18-042MPR– GERMAIN HONDA, PHASE I

Request

Approval of a Minor Project Review for demolition of a 2,000 square-foot building and site improvements for an existing automotive dealership.

4. Site Plan

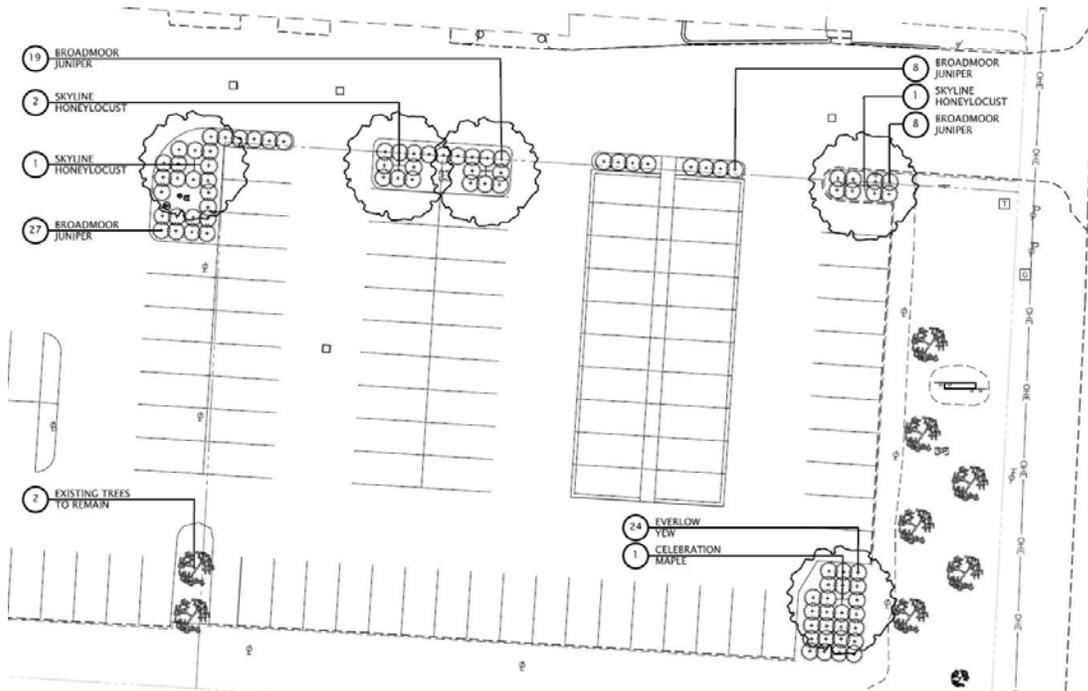
Proposed site plan for the .64-acre impacted portion of the site is shown below. The landscape plan does not indicate the proposed sidewalk alignment, but does demonstrate the proposed parking, landscape, and lighting.

- 1) The applicant work with the City Engineer and City Forester to appropriately and sensitively align and construct a public sidewalk; and,
- 2) The ground sign located south of the southernmost entrance from Sawmill Road be removed within 60-days of approval of a demolition permit for the structure by Building Standards; and,
- 3) The applicant work with the Zoning Inspector and City Forester to determine the appropriate number of tree replacement inches that can be accommodated on-site and the remainder paid as a fee-in-lieu; and,
- 4) A comprehensive Parking Plan be provided to Planning for review and approval with Phase II.
